Dorsey Street and Lake Colby Parking Lots Stormwater Upgrades and Lake Colby Beach Site Civil and Engineering Work

Questions and Answers

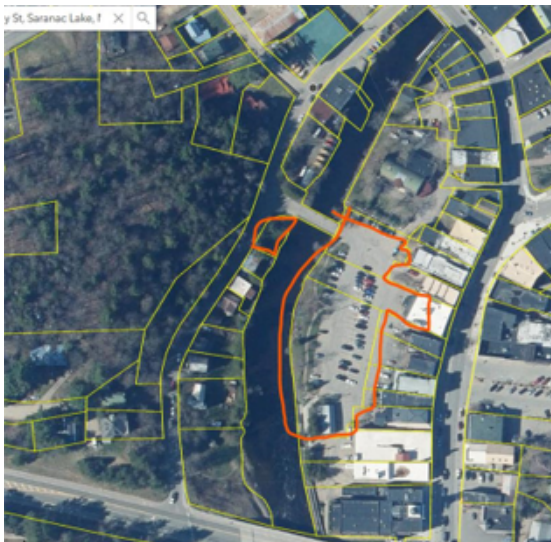
9. Is the consultant supposed to provide a playground specialist and/or plans for the future playground/ fitness area? Is this future playground/ fitness area separate from the comfort station?

For the playground specialist, the Village has someone they are working with. This is a separate area, to the south of the comfort station.
